個別技術要件 「周波数変動時の発電出力 一定維持・低下限度」 中小規模火力発電用原動機 における技術検討結果ご報告

2023年6月7日

(一社) 日本電機工業会
(一社) 日本ガス協会
(一財) コージェネレーション・エネルギー高度利用センター

【周波数低下時のガスタービン出力特性の一例】

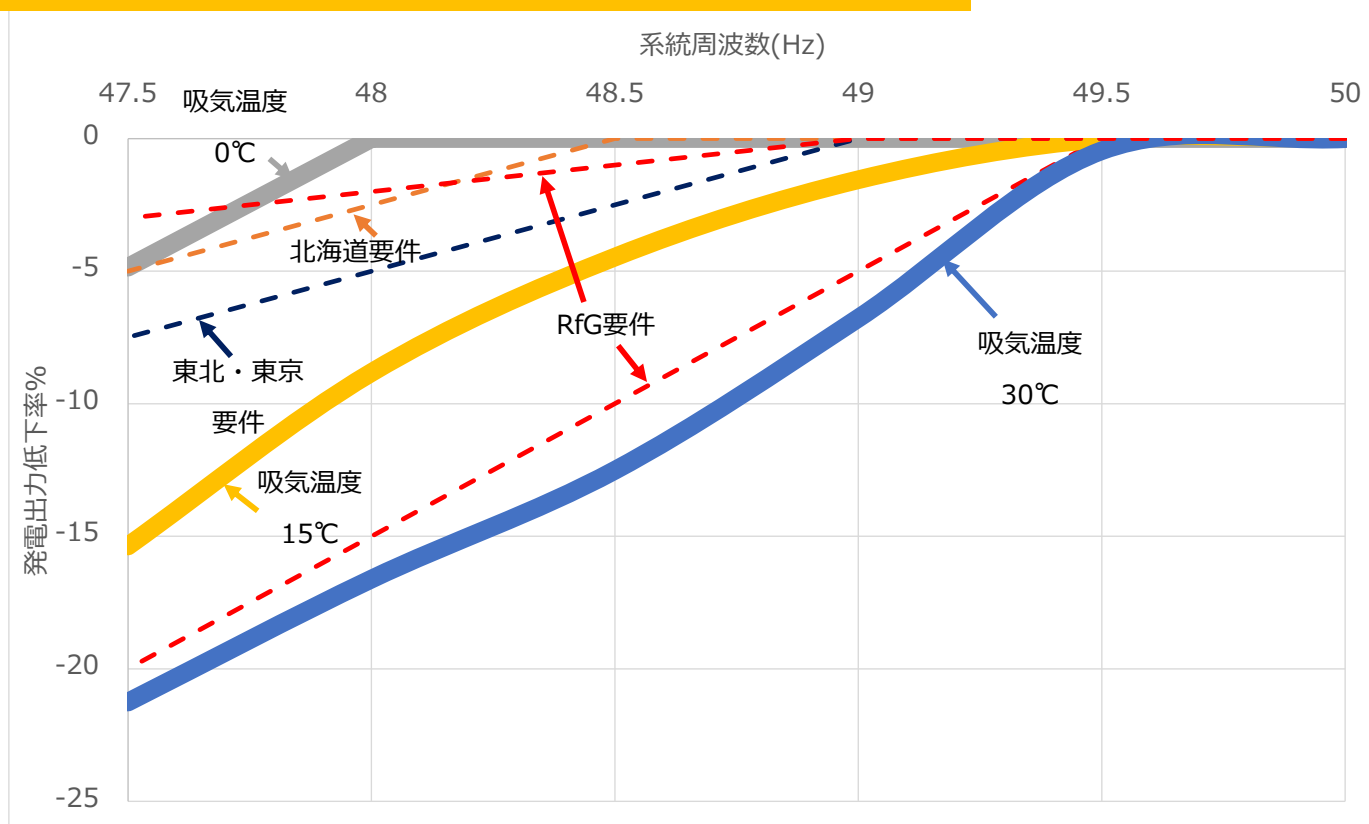
周波数低下時、1軸ガスタービンは下記のような出力特性を示す。課題2は2軸においても同様に影響があるが、1軸と比較して軽微である。

課題1： 周波数低下に伴う圧縮機空気流量低下 ⇒ 発電機出力減

課題2： 出力を維持するため、燃料増 ⇒ 高温部品許容温度超過

課題2. 高温部品許容温度超過

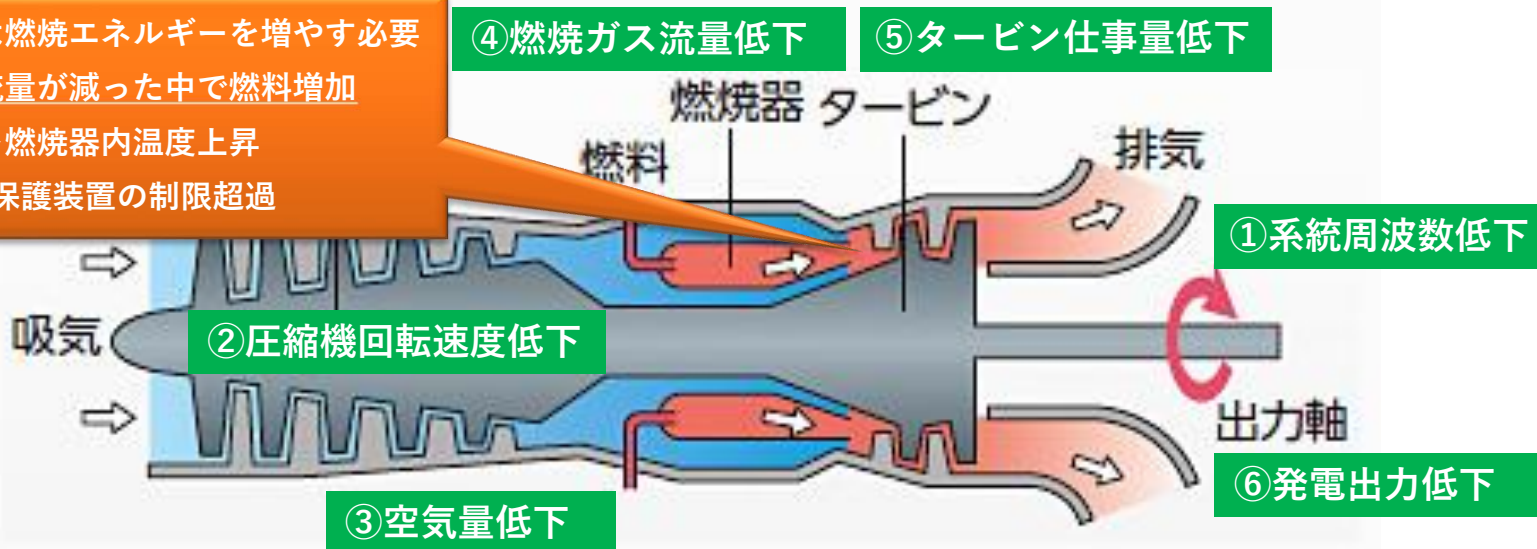
- 系統周波数低下した場合においても、タービンでの仕事量を確保して発電出力を維持し続けようとすると、燃焼ガスのエネルギーが必要ですが、空気流量が低下したまま燃料流量を増加し続ければ、燃焼器内の温度が上昇し、高温部の部品損傷を防ぐ目的で設置されている保護装置(タービン入口温度)の制限を超過し、トリップする。

出力維持には燃焼エネルギーを増やす必要

⇒ 空気流量が減った中で燃料増加

⇒ 燃焼器内温度上昇

⇒ 保護装置の制限超過

Figure 9 Example of active power output of a typical gas turbine with falling frequency (EU turbines year 2011)

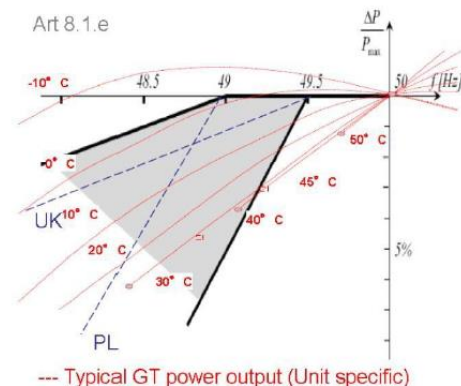
- 欧州RfGのガイドンス文章には、周波数低下とガスタービン出力の関係について解説があります。
 - ✓ 系統の周波数低下によりガスタービンの出力は低下する。
 - ✓ 大気温度がより高温では、周波数低下時の出力維持できる容量はより低下する。
 - ✓ ガスタービンの過負荷回避のため、49Hz以下においては発電出力の低減が行われるはずである。
 - ✓ 一般的には、ガスタービンは連続運転の条件にて10%/Hzの割合で発電出力が低下する。
 - ✓ 一般的にガスタービン定格はISO状態(15℃)で明示する。
- 右図はガイドンス記載のGTの特性グラフであり、2%/Hzへの適合は困難ということが示されています。
- EN50549-2において、発電ユニットが出力低下要件を満たせない場合は、発電事業者とTSO間にて合意しなければならない(shall)との記載があります。
「発電ユニットが指定された環境条件下で出力低減要件を満たさない場合、電力供給者と責任者(TSOなど)は許容可能な環境条件について合意するものとする。」
- ドイツでは「**保護装置の範囲内の運用**」ということで、グリッドコード要件を適用した実績があります。

一般的なガスタービンの特性は赤線の通り
温度が上がるほど、出力低下が大きくなる
